# **FIRE SAFETY INSPECTION REPORT**

**ALIM KNIT (BD) LTD.  
NAYAPARA, KASHIMPUR, GAZIPUR.**

April 12, 2014

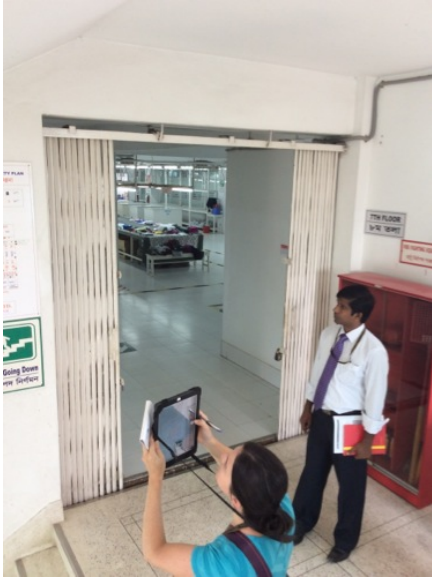
No.	Category	Finding	Recommendation	Remediation Timeframe
F-1	Fire Rated Construction	Hazardous materials / flammable liquid storage area on the sub-building and boiler room is not separated by fire-rated construction.	Separate the hazardous materials / flammable liquid storage room by a minimum 2-hr fire-rated construction. Seal and/or protected all openings to maintain the required fire separations.	Within 3 months

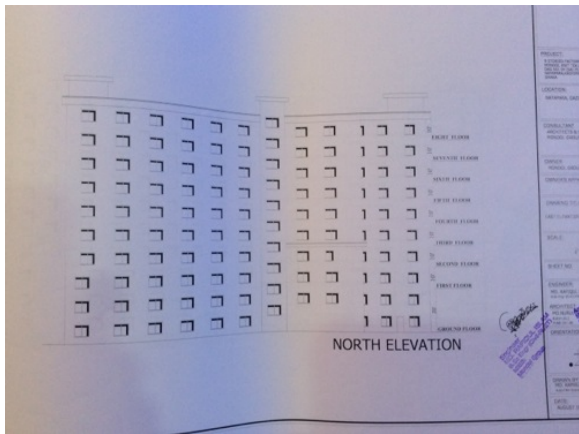
F-13	Fire Protection	The high-rise building has an occupied floor greater than 23m (75 ft) and is not provided with automatic sprinkler protection. The large occupant loads, heavy fuel loading, and anticipated extended egress times warrant sprinkler protection.	Provide automatic sprinkler protection throughout the building in accordance with NFPA 13.	Design within 6 months, install within 12 months
------	-----------------	--	--	--
